Tennessee Valley Authority, Post Office Box 2000, Spring City, Tennessee 37381

WATTS BAR NUCLEAR PLANT (WBN) - REPLY TO REQUEST FOR ADDITIONAL
INFORMATION REGARDING CARBON DIOXIDE AUTOMATIC FIRE SUPPRESSION SYSTEMS
(TAC NO. M63648)

ENCLOSURE 1
WATTS BAR NUCLEAR PLANT (WBN)
REPLY TO REQUEST FOR ADDITIONAL INFORMATION

UNIT 2 AUX. INST. ROOM. WBP

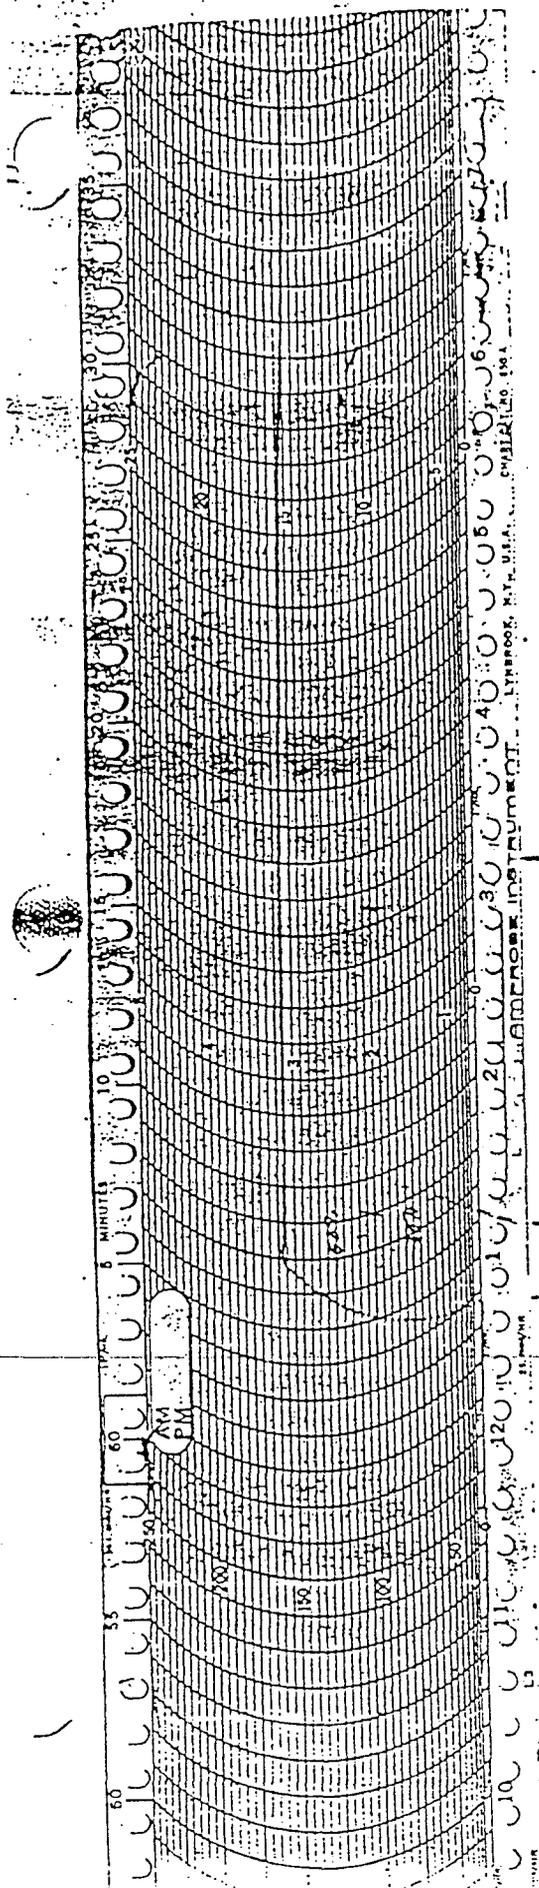
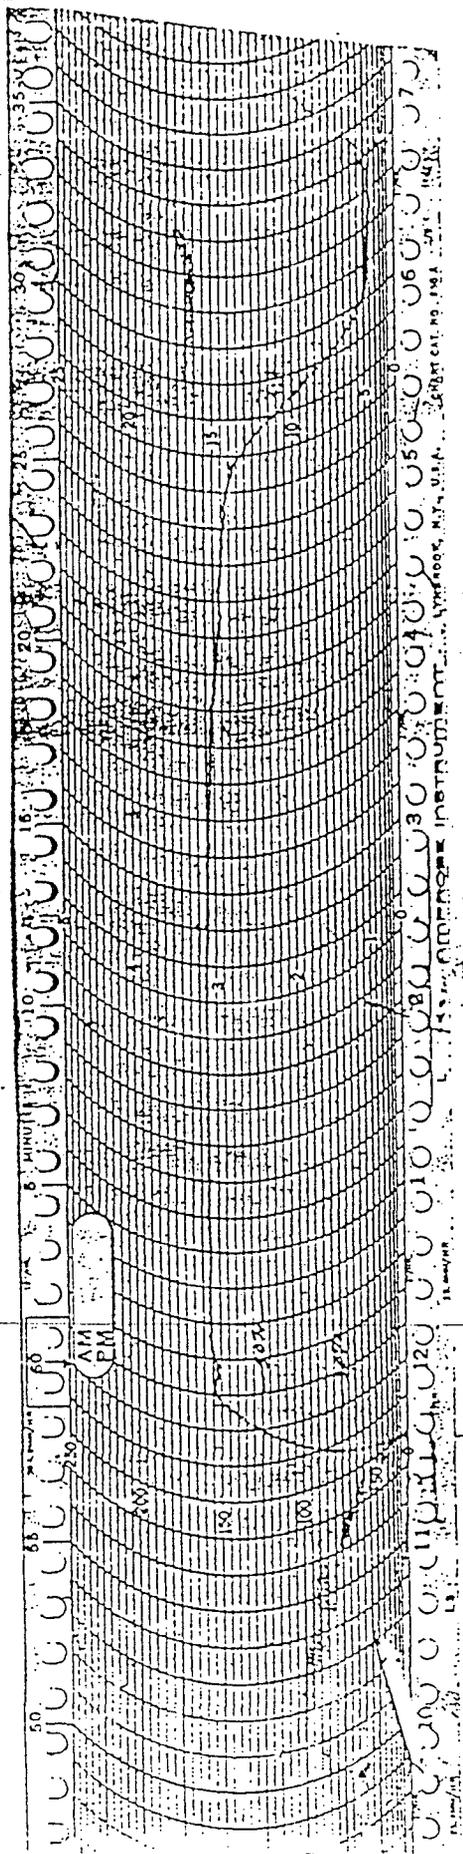
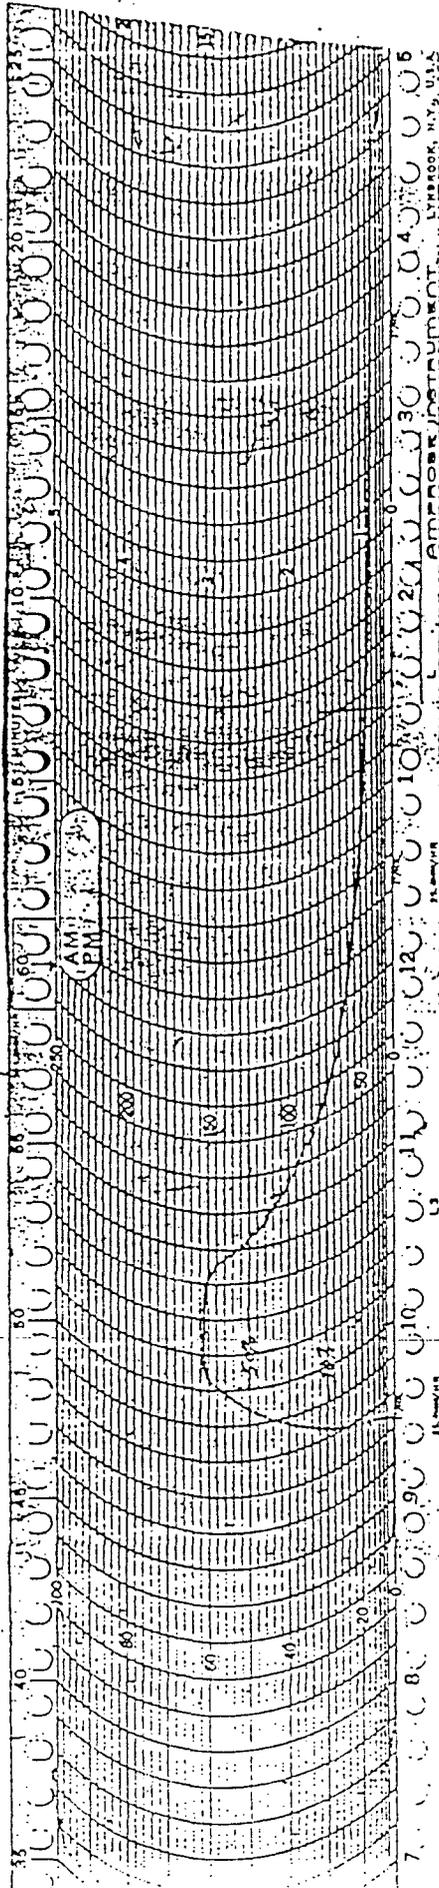
As can be see in the attached graphs (Attachment 6), the auxiliary instrument room CO₂ concentration achieved a concentration of 49%-50%. To ensure greater than 50% CO₂ concentration in the auxiliary instrument rooms, the discharge

timer was increased by 12 seconds, which will result in a concentration of approximately 53%.

FIGURES 34, 36 & 37

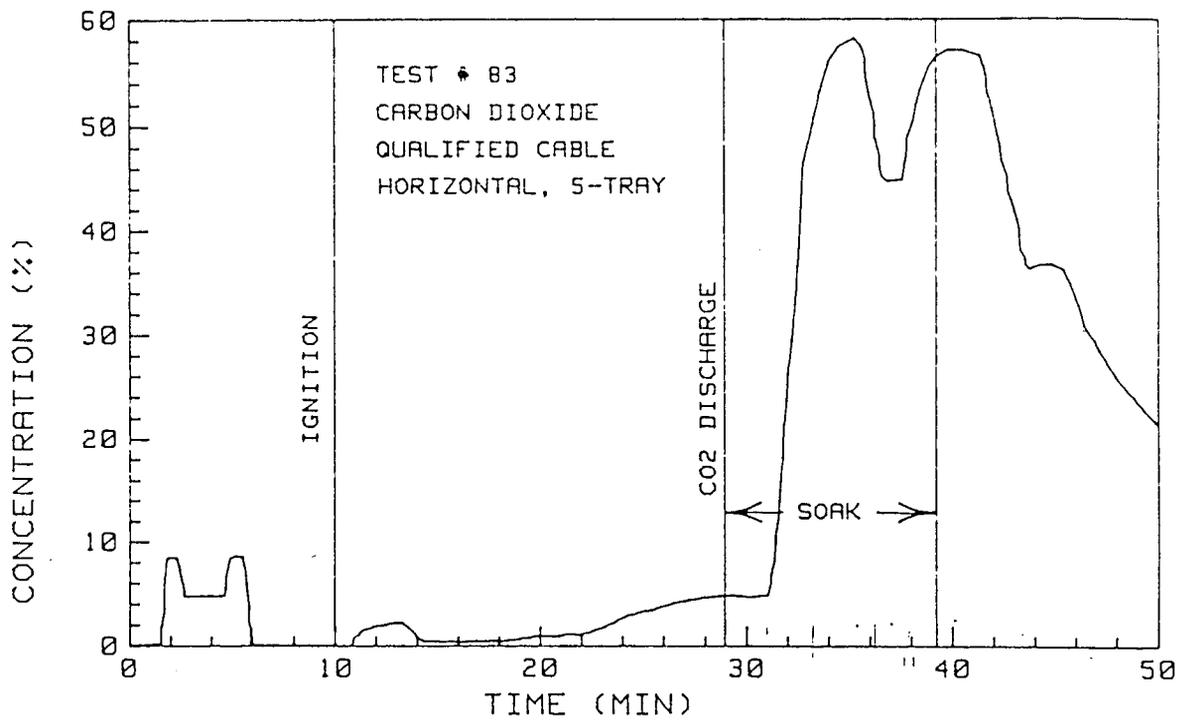
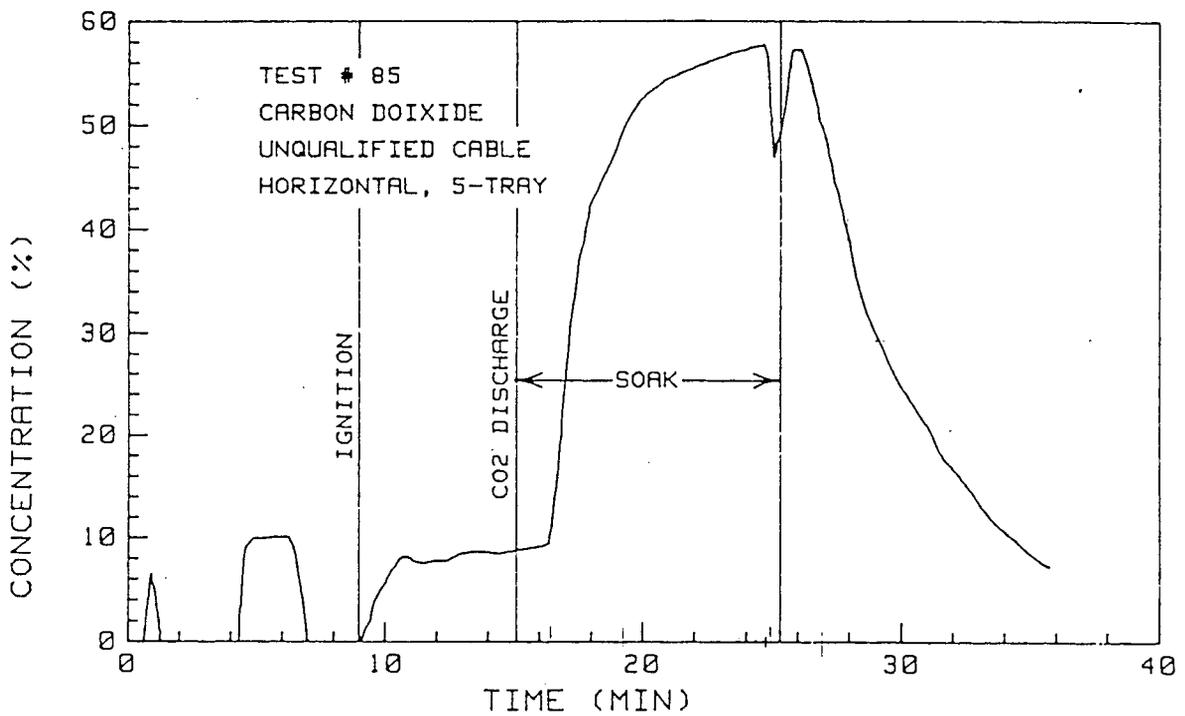
Also, it can be seen from the rapid decay of CO₂ shown in Sandia Figures 36 and 37 that the test room was not a tight room. In contrast, the WBN auxiliary instrument rooms are very tight and are able to maintain the CO₂ for a substantial period of time. A graphical representation of the Sandia test results overlaid with the WBN auxiliary instrument room discharge test (Attachment 4) shows that the WBN enclosure is much tighter than the Sandia

COMPARISON BETWEEN
SANDIA AND TVA CARBON DIOXIDE CONCENTRATION TESTS
(Sandia Figure 36)

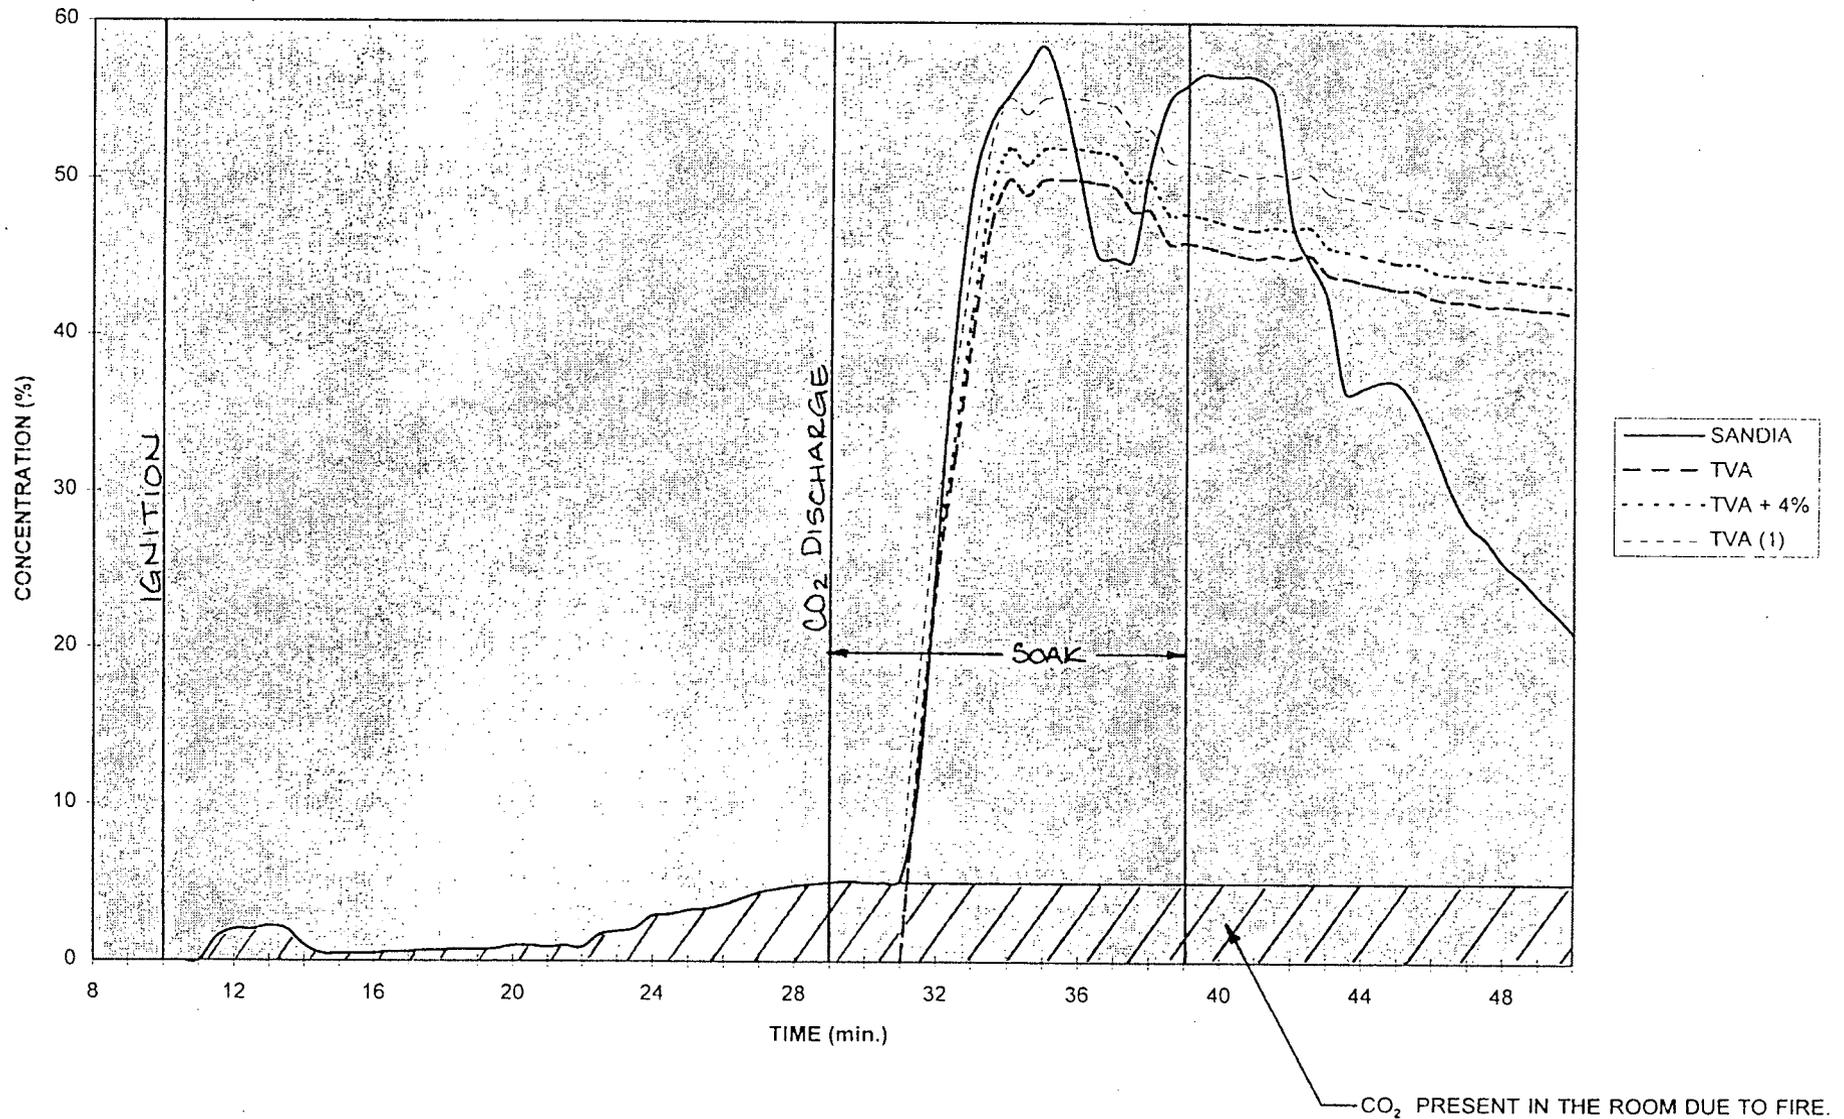
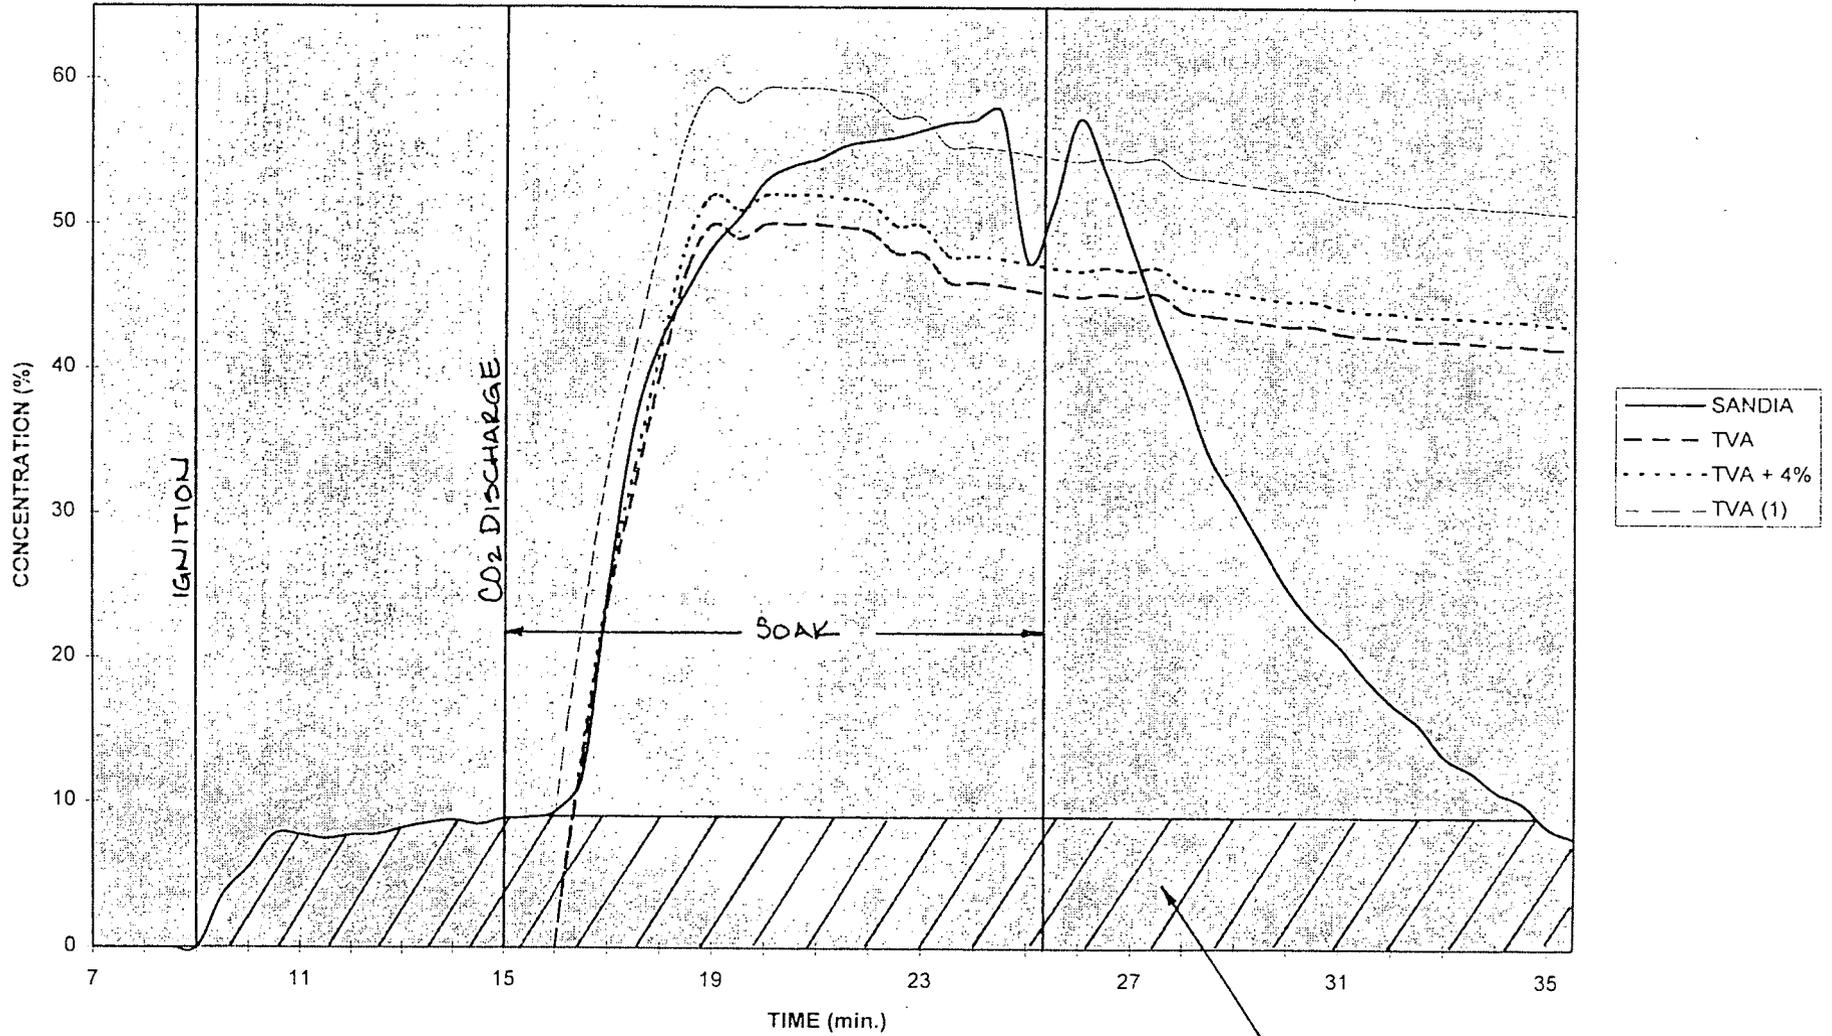
A graphical overlay representation of the Sandia test results and WBN Unit 2 auxiliary instrument room is shown in Attachment 4. Note that at the start of the discharge of CO₂ in the Sandia tests the room's CO₂ concentration was approximately 5%-9%. It appears that this initial contribution of CO₂ is due to the diffusion flaming combustion of the cables. This is consistent with the discussions of the physical chemistry of combustion in fires as presented by D.D. Drysdale in his book "An Introduction to Fire Dynamics." This additional CO₂ that is produced in an actual fire will contribute to the CO₂ system discharge and produce a synergetic effect on smothering the fire (i.e., reducing the oxygen content of the atmosphere by dilution to a level where the atmosphere no longer will support combustion). As noted, the WBN test results, with the additional CO₂ that would result from the timer increase, ensures a sufficient concentration for extinguishment as bounded by the Sandia tests. Therefore, the performance criteria of NFPA 12-1973, Section 2523 have been met and adequate concentration levels and soak times have been accomplished.
